# Rezoning Transportation Analysis

Petition Number: 2018-122

General Location Identifier: 12510411, 12510409

Date	Description
10-17-18	First Review

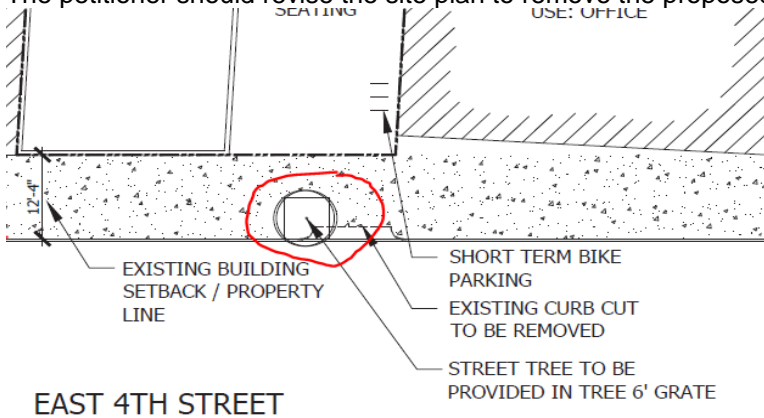
1. **Curblin** The proposed zoning district has a setback measured from back of the existing or proposed future curblin. The location of the future back of curb on East 4<sup>th</sup> street is 24.5' from centerline and is in its existing location on South Torrence Street.
2. **Traffic Study** A Traffic Impact Study is not necessary for the complete review of this petition.
3. The petitioner should revise the site plan and conditional note(s) to install 2 ramps at the corner of South Torrence Street and East 4<sup>th</sup> Street.

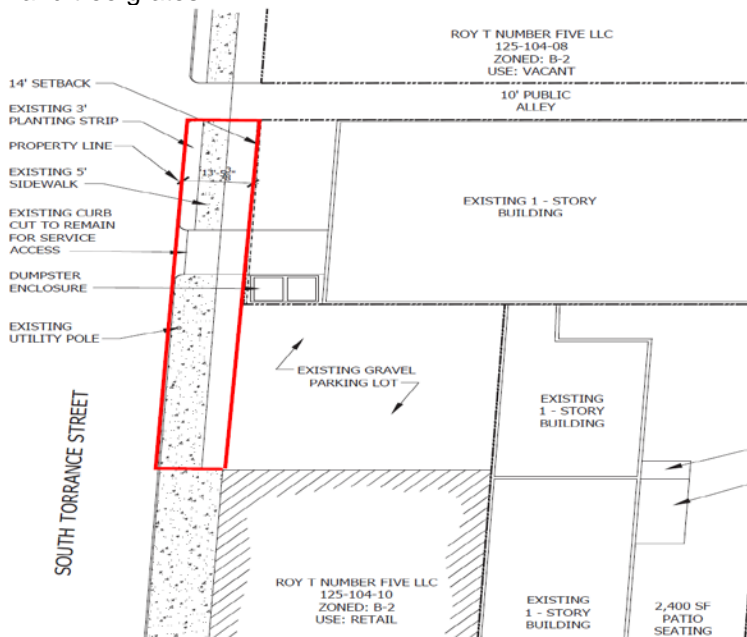
4. The petitioner should revise the site plan to remove the proposed street tree.

5. The petitioner should revise the site plan and conditional note(s) to upgrade frontage along South Torrance Street to have an obstructed 16' wide amenity zone at the back of curb to accommodate for sidewalk and tree grates.
